ANNEX 8**RESOLUTION MSC.222(82)****(adopted on 8 December 2006)****ADOPTION OF AMENDMENTS TO THE INTERNATIONAL CODE
OF SAFETY FOR HIGH-SPEED CRAFT, 2000**

**AMENDMENTS TO THE INTERNATIONAL CODE OF SAFETY
FOR HIGH-SPEED CRAFT, 2000**

Figure 2.6.7a

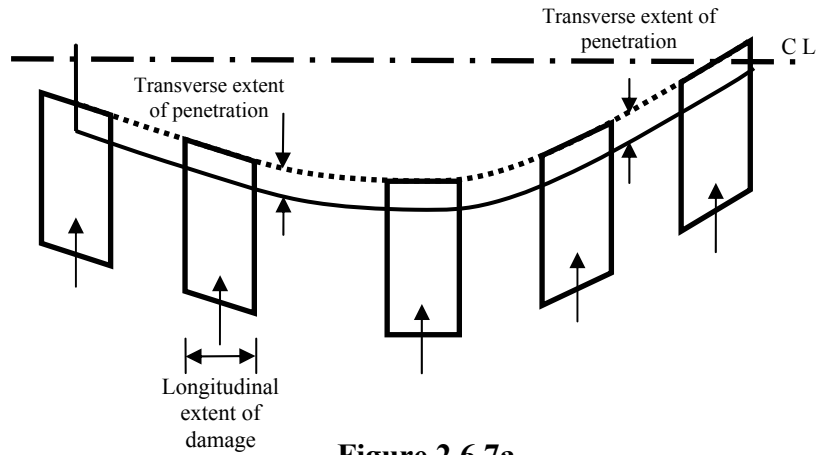
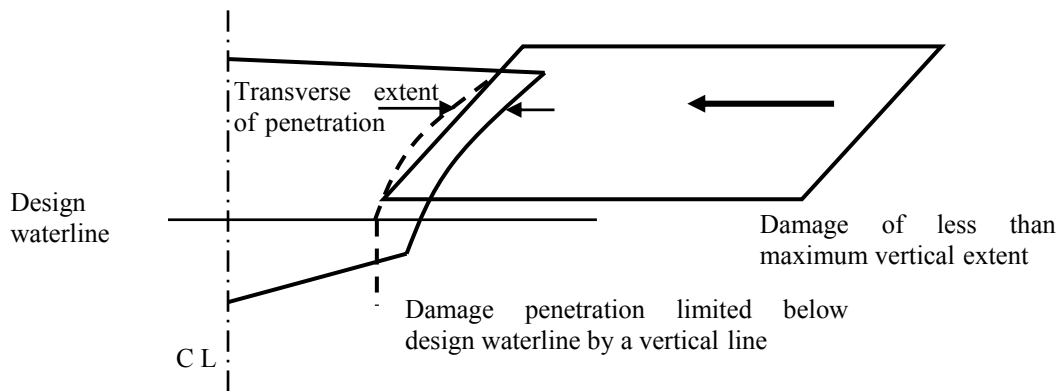
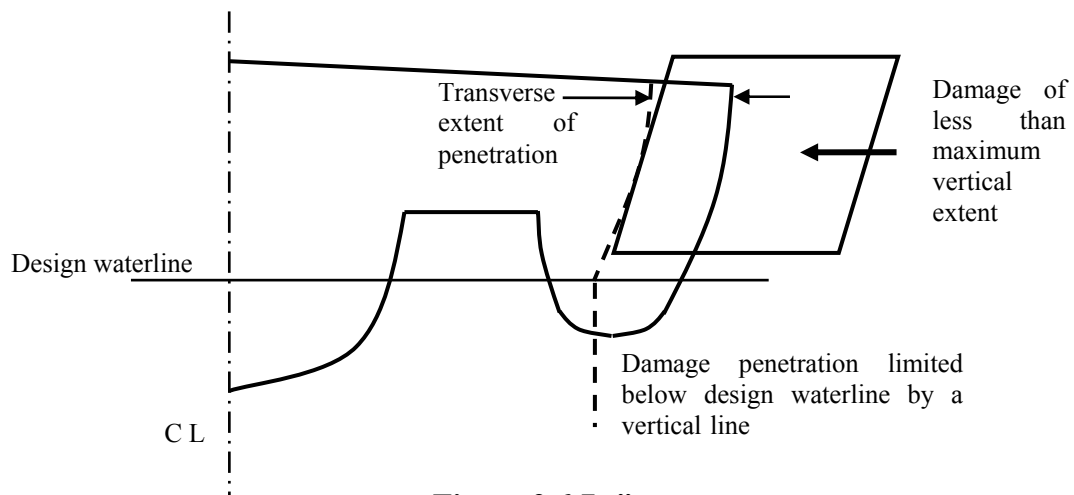
24 The following new section of text is added in continuation of paragraph 2.6.7 after subparagraph 2.6.7.3:

“The damages described in this paragraph shall be assumed to have the shape of a parallelepiped.* Applying this to figure 2.6.7 a, the inboard face at its mid-length shall be tangential to, or otherwise touching in a least 2 places, the surface corresponding to the specified transverse extent of penetration, as illustrated in figure 2.6.7 a.

Side damage shall not transversely penetrate a greater distance than the extent of $0.2\nabla^{1/3}$ at the design waterline, except where a lesser extent is provided for in 2.6.7.2. Refer to figures 2.6.7b and c.

If considering a multihull, the periphery of the craft is considered to only be the surface of the shell encompassed by the outboard surface of the outermost hull at any given section.

Figure 2.6.8”

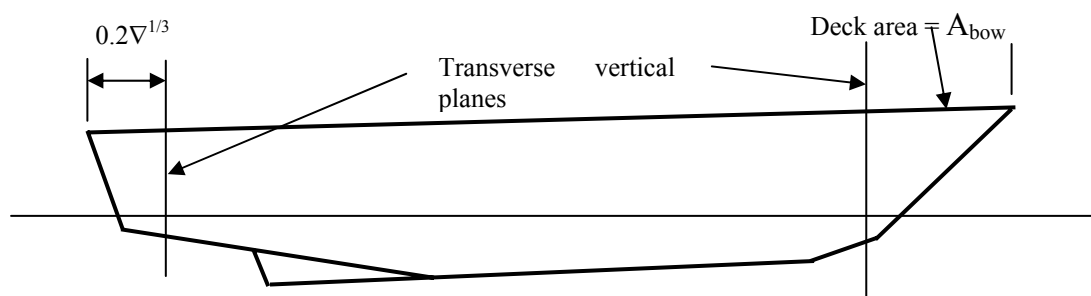
“2.6.8 Extent of bow and stern damage

2.6.8.1 The following extents of damage are to be applied to bow and stern, as illustrated in figure 2.6.8:

- .1 at the fore end, damage to the area defined as A_{bow} in 4.4.1, the aft limit of which being a transverse vertical plane, provided that this area need not extend further aft from the forward extremity of the craft’s watertight envelope than the distance defined in 2.6.7.1; and
- .2 at the aft end, damage to the area aft of a transverse vertical plane at a distance $0.2\nabla^{1/3}$ forward of the aft extremity of the watertight envelope of the hull.

2.6.8.2 The provisions of 2.6.6 in relation to damage of lesser extent remain applicable to such damage.

Figure 2.6.9.2

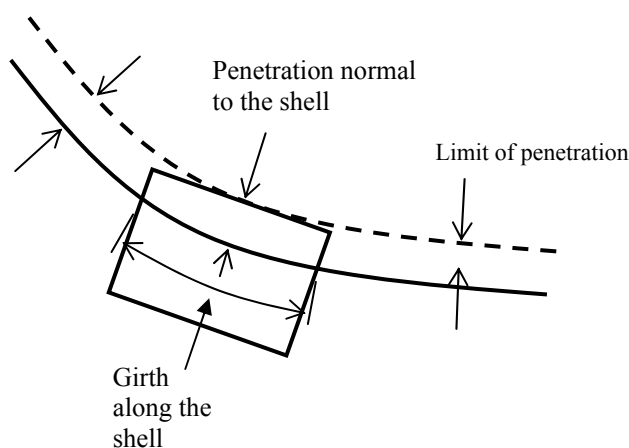
29 The following new paragraph 2.6.9.2.3 is inserted after the existing paragraph 2.6.9.2.2:

“2.6.9.2.3 The shape of damage shall be assumed to be rectangular in the transverse plane as illustrated in figure 2.6.9.2 below. Damage is to be assumed at a series of sections within the defined longitudinal extent in accordance with figure 2.6.9.2, the mid-point of the damaged girth being maintained at a constant distance from the centreline throughout that longitudinal extent.

“.4 the shape of damage shall be assumed to be rectangular in the plane of the shell of the craft, and rectangular in the transverse plane as illustrated in figure 2.6.9.2.”

Figure 7.3.4a

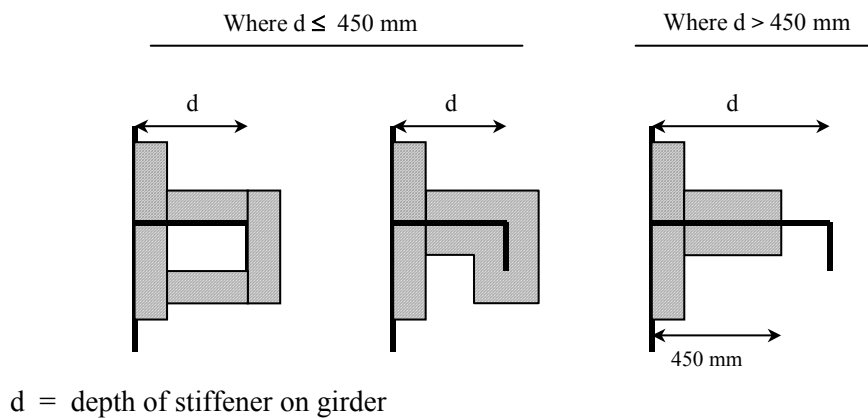
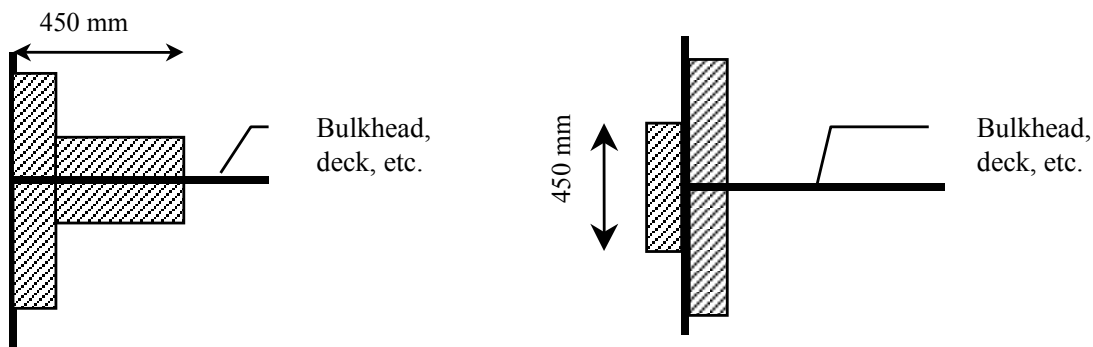
55 The following new paragraphs 7.3.4 to 7.3.6 and associated figures 7.3.4a, 7.3.4b and 7.3.6 are inserted after the existing paragraph 7.3.3:

“7.3.4 To prevent heat transmission at intersections and terminal points, the insulation of the deck or bulkhead shall be carried past the intersection or terminal point for a distance of at least 450 mm in the case of steel or aluminium structures (refer to figures 7.3.4a and 7.3.4b).

Figure 7.3.6

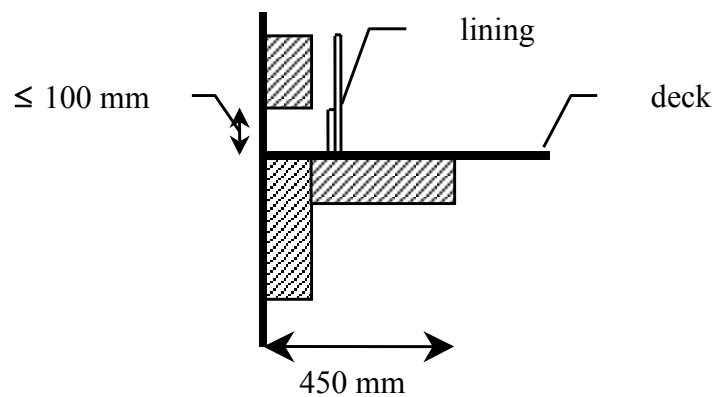
7.3.6 Where the lower part of the fire insulation has to be cut for drainage, the construction shall be in accordance with the structural details shown in figure 7.3.6.”
